PROJECT NAME: PD Development Plan for Vallis Greene

02/24/2022: Z2022-010; Zoning Change (AG to PD) for Vallis Greene

- 1.1 This request is for the approval of a Zoning Change from an Agricultural (AG) District to a Planned Development District for Single-Family 10 (SF-10) District land uses on a 93.97-acre tract of land identified as Tract 4-01 of the M. B. Jones Survey, Abstract No. 122, City of Rockwall, Rockwall County, Texas, zoned Agricultural (AG) District, situated within the SH-66 Overlay (SH-66 OV) District, and addressed as 1936 SH-66.

OPEN SPACE RATIO* [(29.72/2) + 12.93] / 93.97 =29.6% VALLIS GREENE 93.97 ACRES

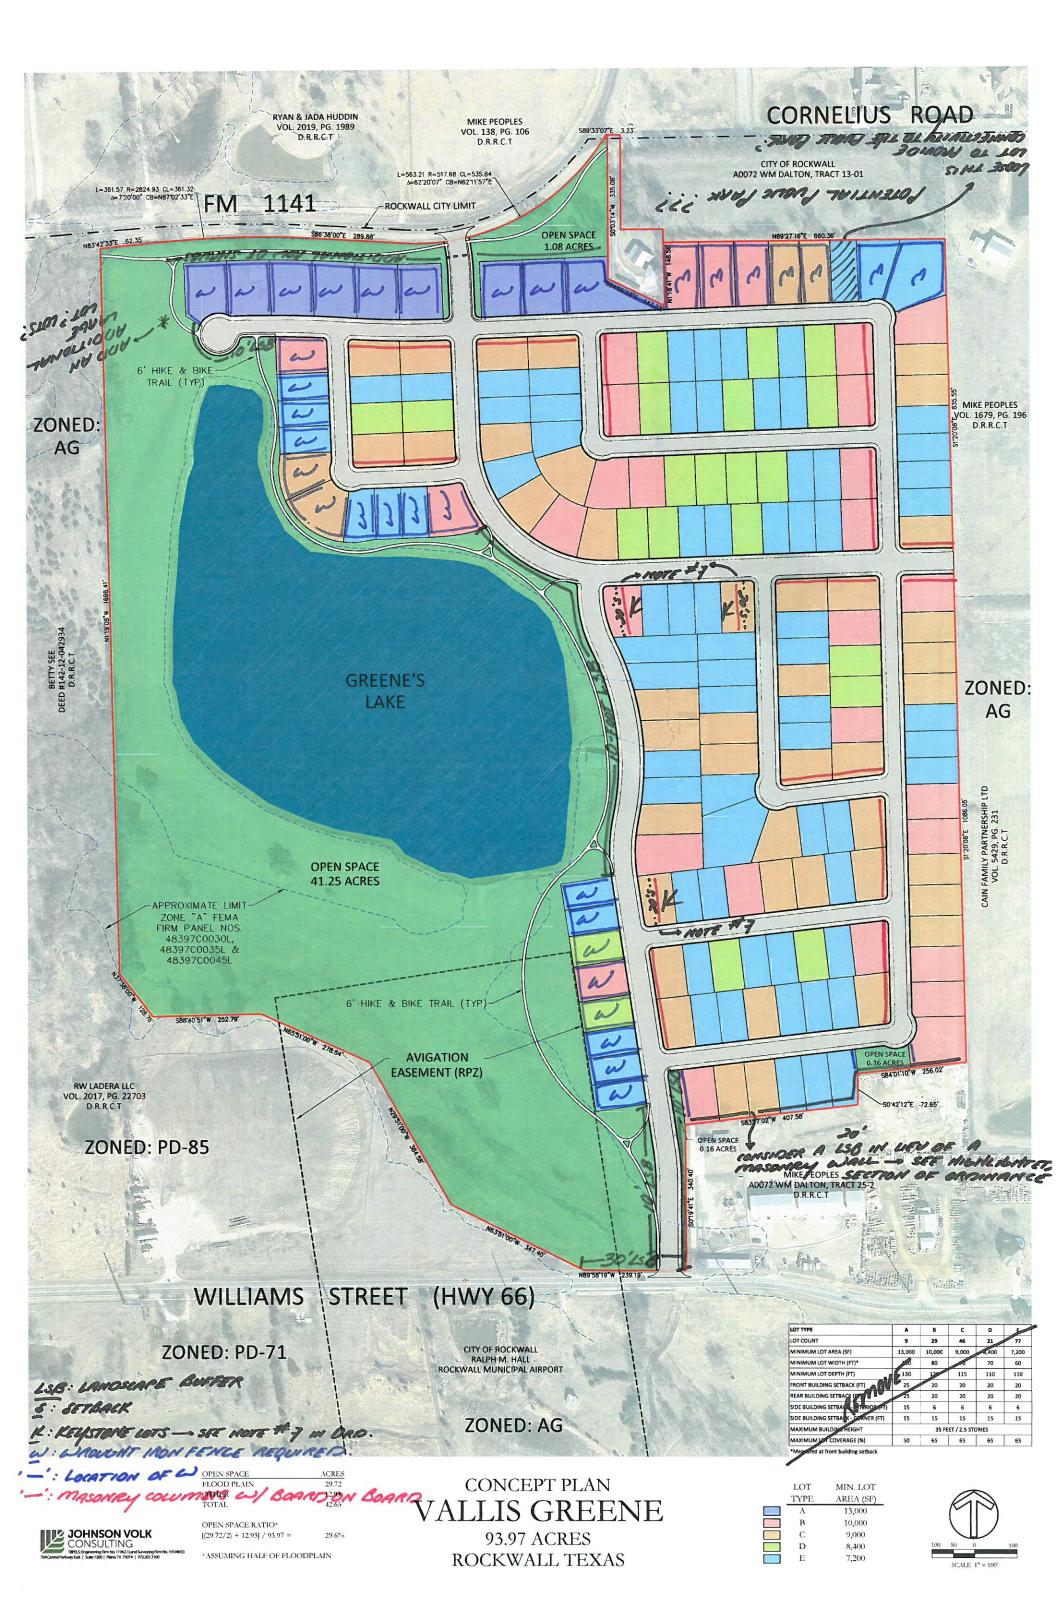
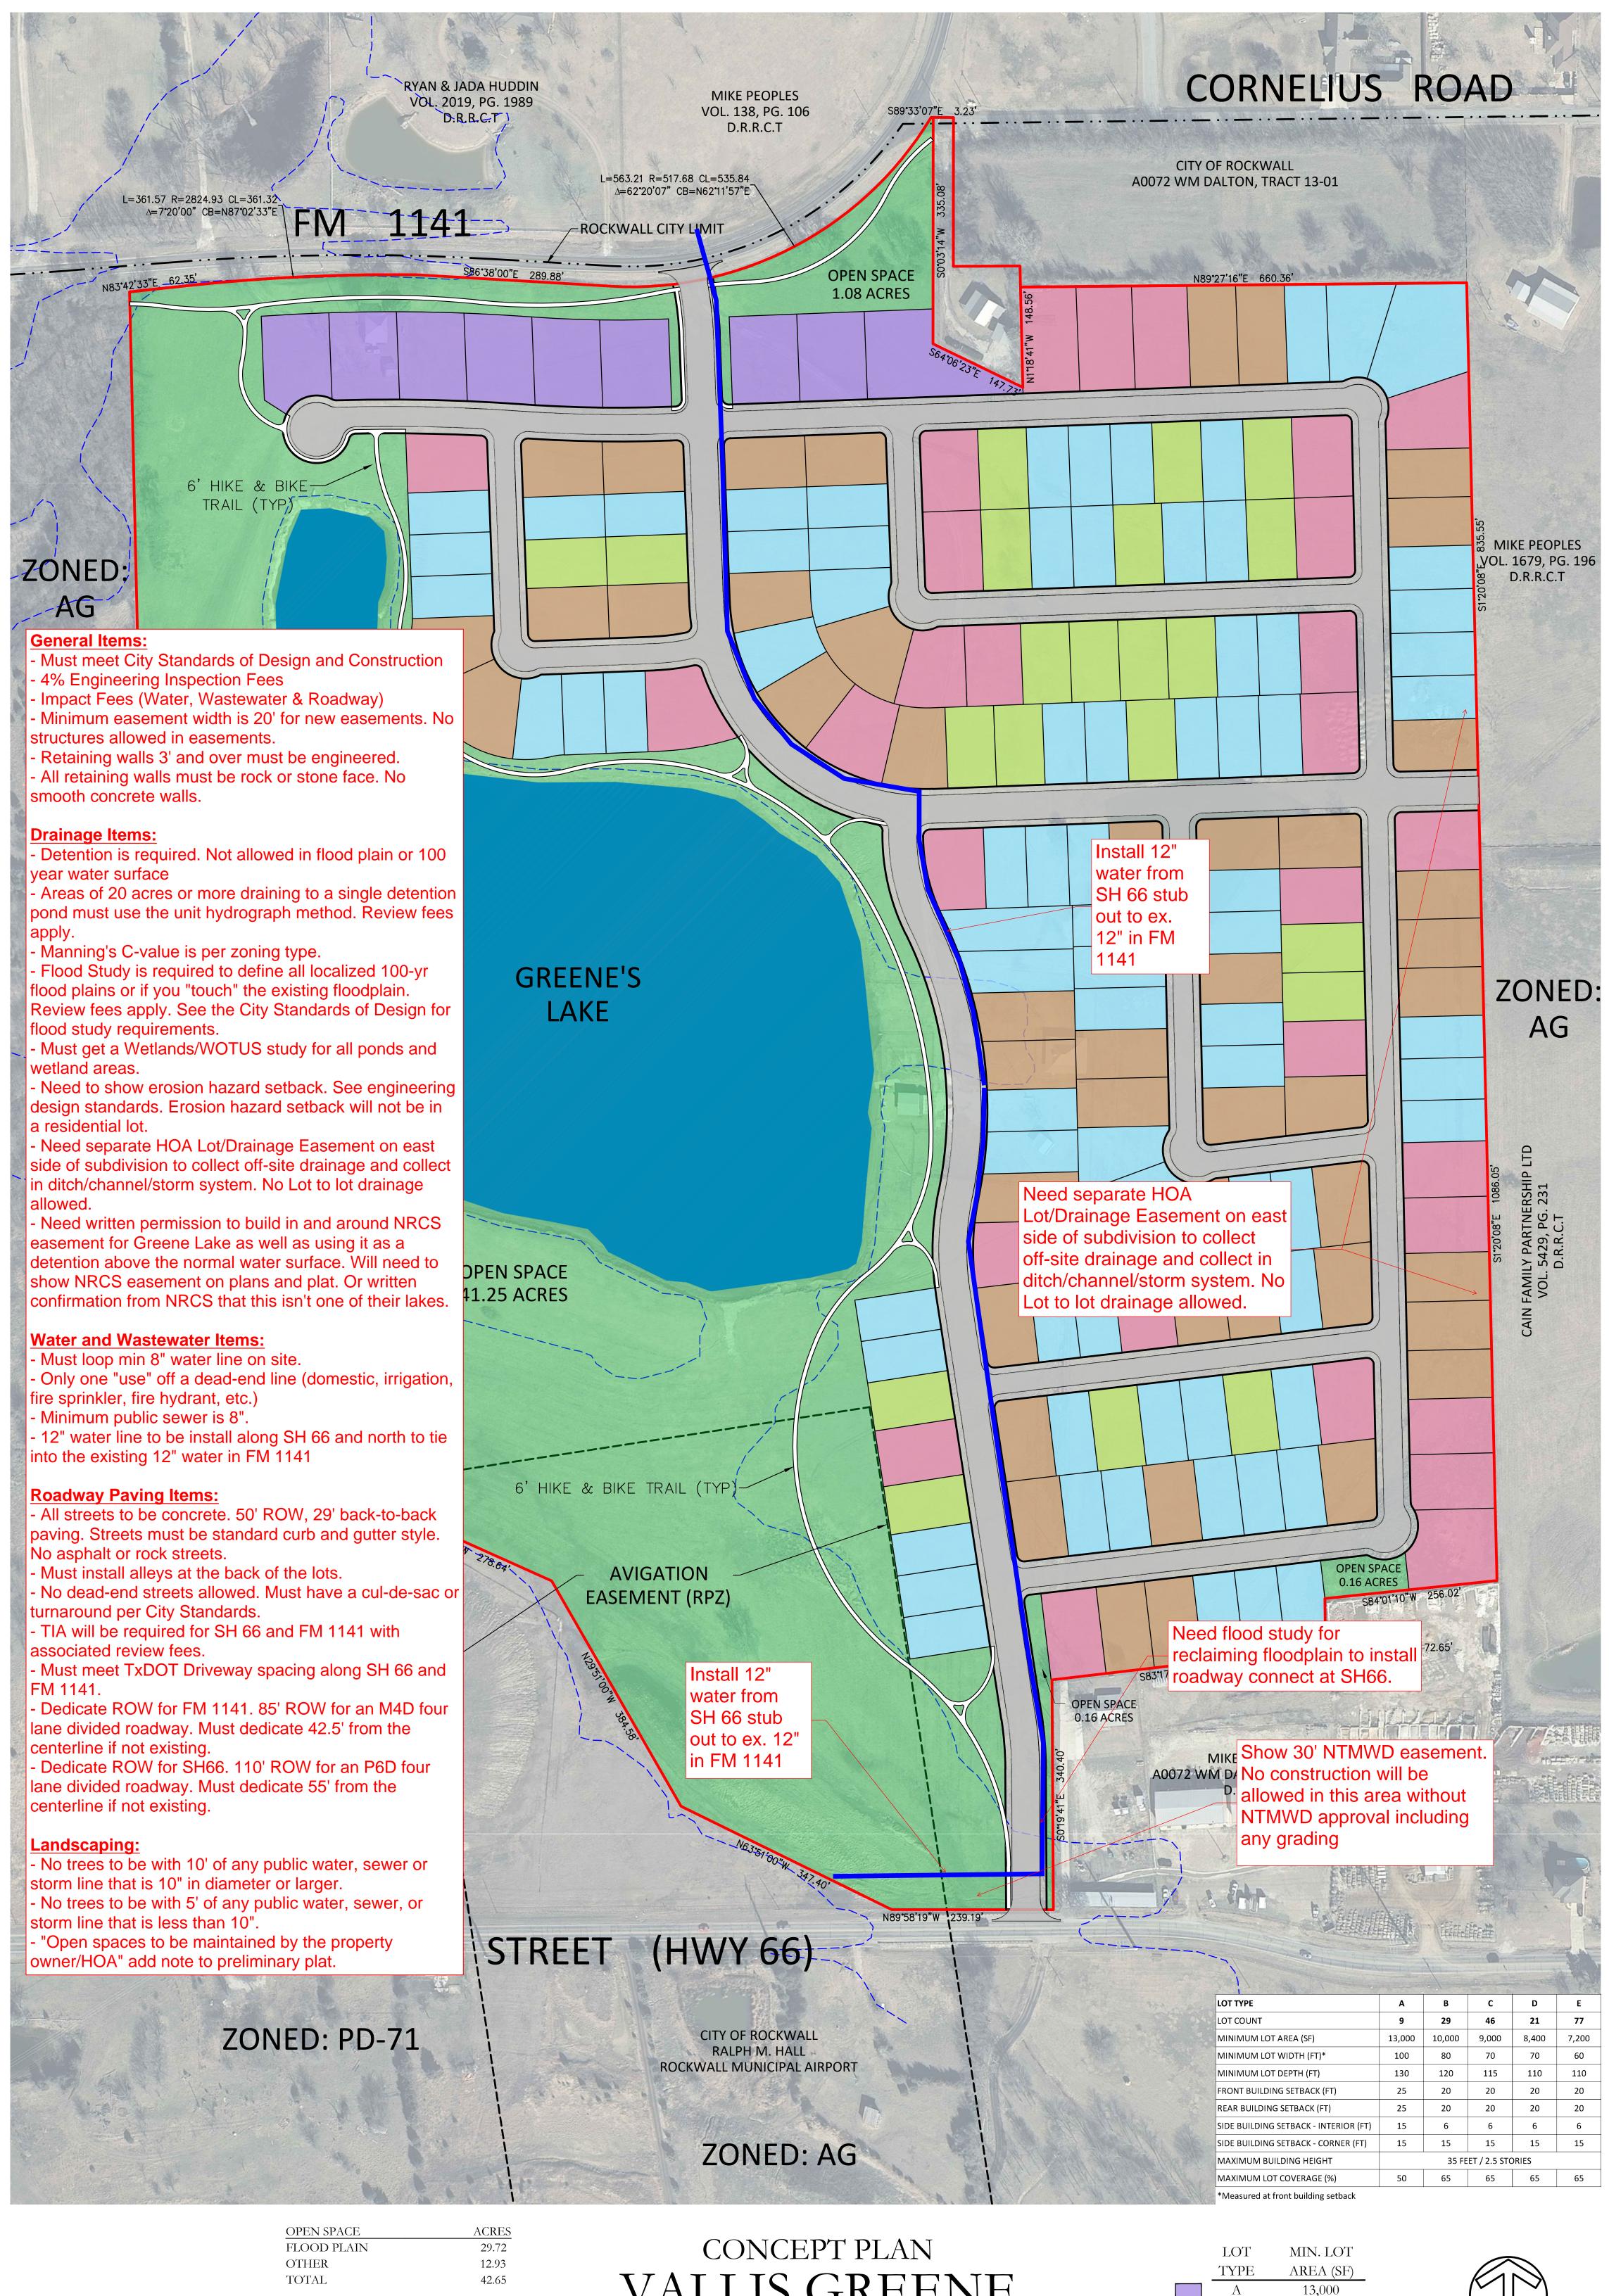
- M.8 Please address the following on the Concept Plan:
- (1) Please remove the Density and Dimensional chart off of the Concept Plan.
- (2) Please indicate monument signage locations on the Concept Plan.

- (3) Please indicate that all lots less than 12,000 SF are located within 800-feet of a public or private open space.
- (4) Please add a 20-foot landscape buffer adjacent to the non-residential land use adjacent to the southern boundary (see staff's comments below concerning what is required within this buffer).

- (3) Please note that nothing can be constructed within the Runway Protection Zone (RPZ) of the Ralph Hall Municipal Airport (see Planning Markups).
- (4) Currently, the Unified Development Code (UDC) would require a minimum of a six (6) foot masonry fence adjacent to the non-residential land use along the southern property line; however, this can be substituted for a 20-foot landscape buffer, berm and three (3) tiered landscaping. Staff has added a highlighted section into the draft ordinance proposing this alternative screening. Despite which option is chosen, this will need to be addressed in the draft ordinance.

- (6) Staff has prepared a marked-up Concept Plan that shows the location of the fencing, setbacks, landscape buffers, comments and recommendations per the Draft Ordinance and these comments.
